## Change OMNIMATE® Power SU 10.16IT

Type of notification: ☒ PCN ☐ PDN ☐ Short-term action (<6 months)

### 1. General Overview

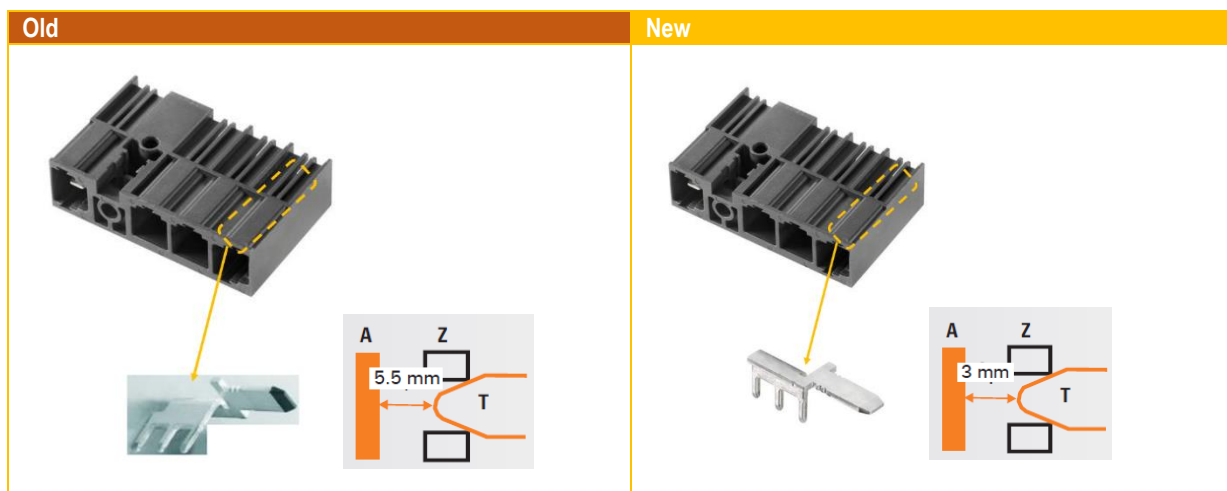
To sustainably improve availability, the overmolded, insulated pin tips of the SU 10.16 IT pin headers are replaced by Weidmüller standard pins. In the unmated state, the finger safety in the mating face is reduced from 5.5 mm to 3 mm. All technical data with mated counterpart (Weidmüller BUZ/BUF series) remain unaffected.
